**Subject:** Application for Renewal and Revision to Certificate of Compliance No. 9233 for the Model No. TN-RAM Transportation Packaging, Response to Request for Additional Information (Docket No. 71-9233, TAC Nos. L25001 and L25002)

**RAI Responses**

**Figure 5-8**  
*Additional Source Configurations*

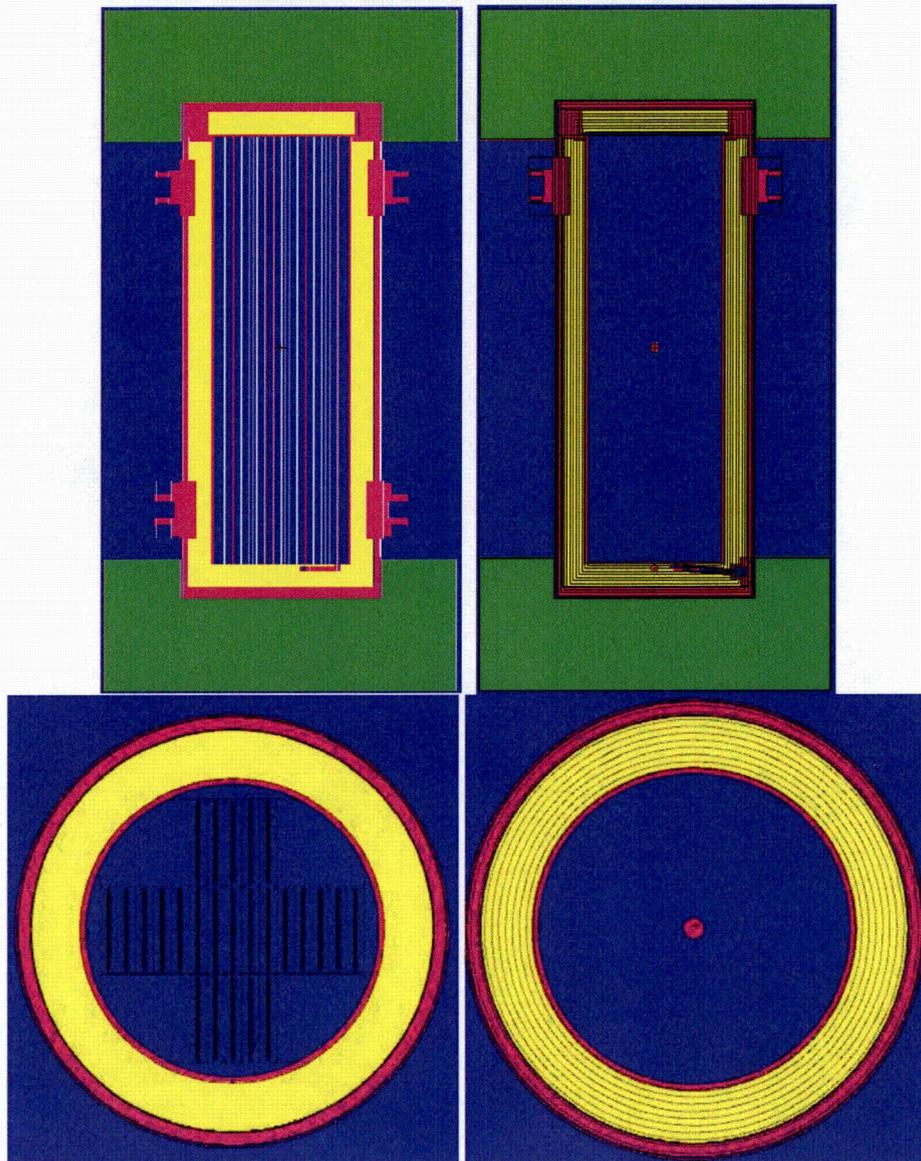
Discuss if there will be concentration of sources.

The *first* four postulated source configurations are shown in axial views in Figure 5-2 and in radial view in Figure 5-3. The radial views are slices through the approximate center of the respective source region. *The final two configurations are shown in Figure 5-8.*
